UNITED STATES
DEPARTMENT OF THE INTERIOR
BUREAU OF LAND MANAGEMENTFORM APPROVED
OMB No. 1004-0137
Expires: July 31, 2010**SUNDRY NOTICES AND REPORTS ON WELLS**
Do not use this form for proposals to drill or to re-enter an abandoned well. Use Form 3160-3 (APD) for such proposals.5. Lease Serial No.
NM-10186

☐ Oil Well ☐ Gas Well ☐ Other INJECTION8. Well Name and No.
WEST DOLLARHIDE DRINKARD UNIT #512. Name of Operator
CHEVRON U.S.A. INC.9. API Well No.
30-025-122793a. Address
15 SMITH ROAD
MIDLAND, TEXAS 797053b. Phone No. (include area code)
432-687-737510. Field and Pool or Exploratory Area
DOLLARHIDE TUBB DRINKARD4. Location of Well (Footage, Sec., T., R., M., or Survey Description)
2310' FNL & 330' FEL, SECTION 31, T-24S, R-38E UL: H11. Country or Parish, State
LEA COUNTY, NEW MEXICO

Objective: Repair Wellhead, Plumb Risers and Return to Injection

Conditions of Approval

Schematic - Current

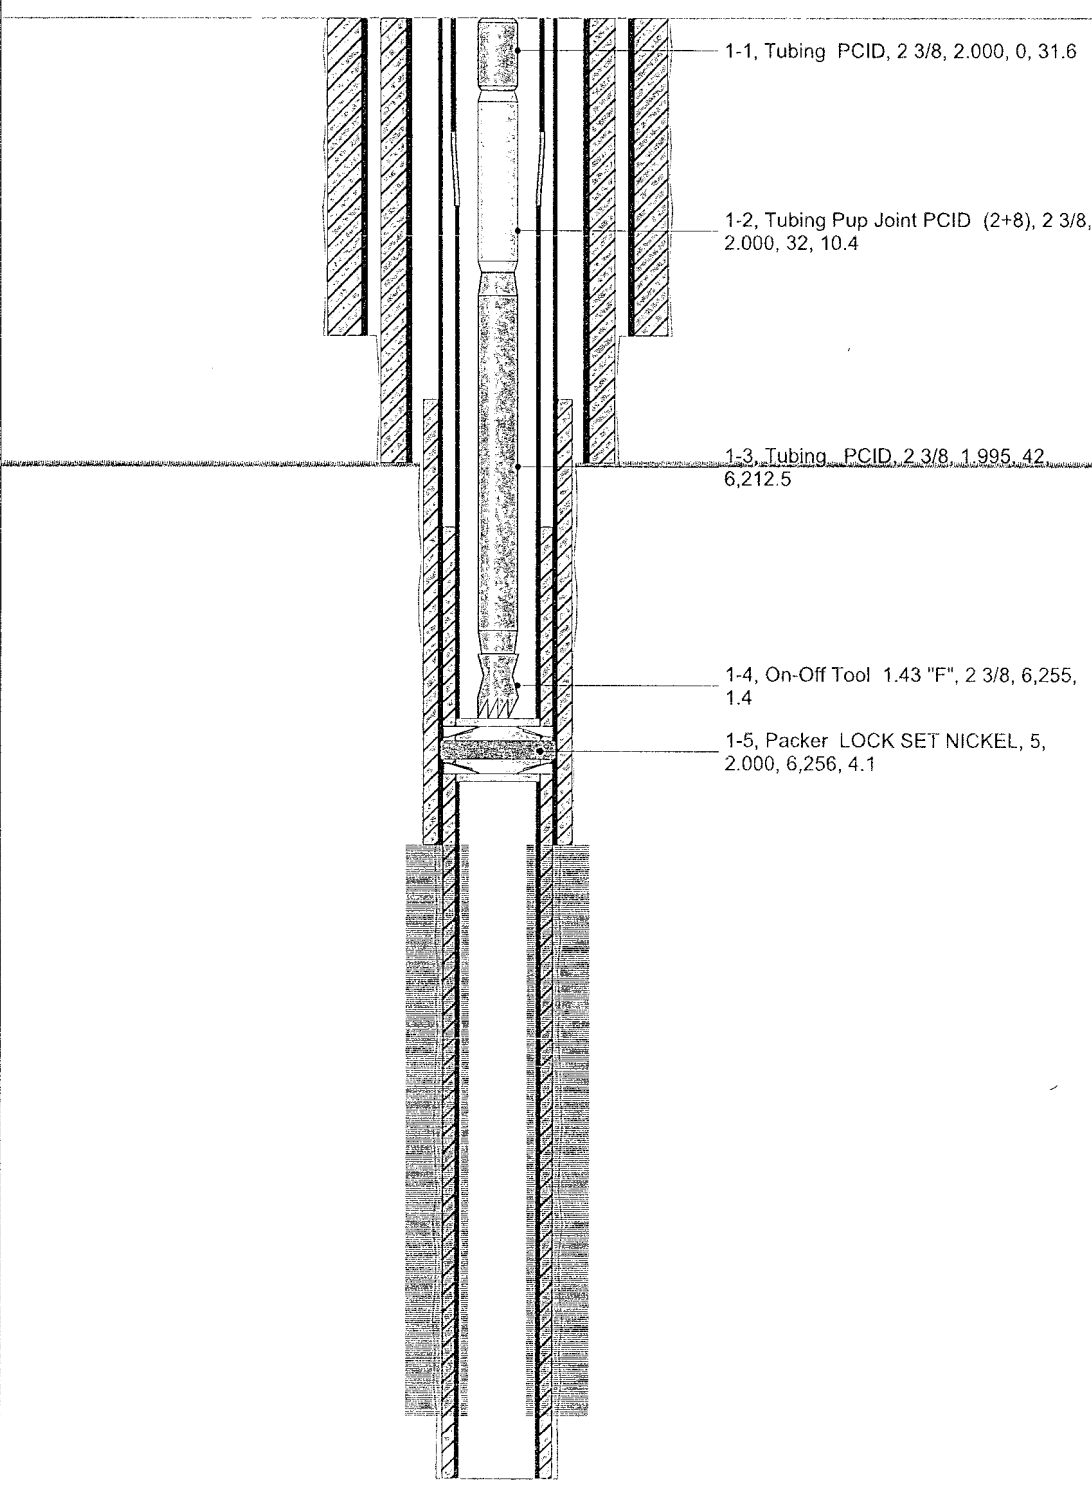
- 1. Operator states that well passed an MIT in July 2010. It appears that test was performed, but pursuant to sundry remarks, the test was not witnessed by NMOCD or BLM.**

- 2. Operator has been reporting an injection pressure of 1600 psi for the past four years when the well was injecting. Operator shall install a Scada monitoring system on the tubing/casing annulus with a high pressure shutdown of injection at 300 psi. The monitoring system shall shut in the well and provide an alarm. System to be operational prior to placing well back on injection. Details of what has been installed to be submitted on subsequent sundry detailing work to place well back on injection. Exact date well is placed back on injection shall be listed.**

- 3. Contact BLM and NMOCD prior to official MIT test. Conduct a Mechanical Integrity Test of at least 500 psig for 30 minutes on the injection tbg/csg annulus of the well. The test pressure should have at least 200 psig differential with tubing pressure but no more than casing test pressure as described by Onshore Order 2.III.B.1.h. (tubing pressure may need to be reduced). Document the MIT test on a calibrated recording chart registering 25 to 85 per cent of its full range. Notify Paul R. Swartz at 575-200-7902 at least 24 hours before the test. If there is no response, notify the BLM via on call drilling phone, 575-361-2822. Submit the recorded MIT chart with a subsequent Sundry Form 3160-005 relating the MIT activity. Include the original and three copies of the recorded chart and Sundry.**

- 4. A wellhead bradenhead test shall be conducted during the MIT. Each casing annulus shall be open to the atmosphere for observation before and during the test.**

- 5. Submit documentation of the maximum tubing injection pressure allowed by NMOCD. Compliance with this injection pressure is required. Display real time tubing pressure values onsite. A bourdon tube gauge registering 25 to 85 per cent of its full range is acceptable. Within 24 hours report injection pressure observed above the NMOCD maximum. Should wellhead injection pressure reach 50psig below this maximum, install automation equipment that will prevent exceeding that maximum. Submit a subsequent report (Sundry Form 3160-5) describing the installed automation equipment. Report any other unexplained significant variations of rate or pressure.**

- 6. Display tubing-casing annular pressure onsite. A bourdon tube gauge that will register tubing pressure within 25 to 85 per cent of its full range is acceptable. Should the casing/tubing annulus exhibit communication with injection pressure, a tubing or packer failure probable. Monitor the annulus. The use of automation equipment that will monitor and alarm is encouraged for any well and necessary when tubing or casing competence is questionable. Maintain the annulus full of packer fluid and be able to verify that fluid level to a BLM inspector at any time. Report a significant (5bbl/month) loss of packer fluid. Should tubing or casing failure be detected, cease injection and reduce the annular pressure to 0psig. Notify Paul R. Swartz at 575-200-7902 within 24 hours. If there is no response, notify the BLM on call drilling phone, 575-361-2822. Also submit to this office on a notice of intent (Sundry Form 3160-5) for approval by BLM and NMOCD, a plan of correction and the anticipated date of repair. After the repairs submit a subsequent report (Sundry Form 3160-5) describing the repair(s) and a BLM witnessed Mechanical Integrity Test chart. Include the date(s) of the well work, descriptions of tubing, on/off equipment, profile nipple installation, and packer setting depth.**
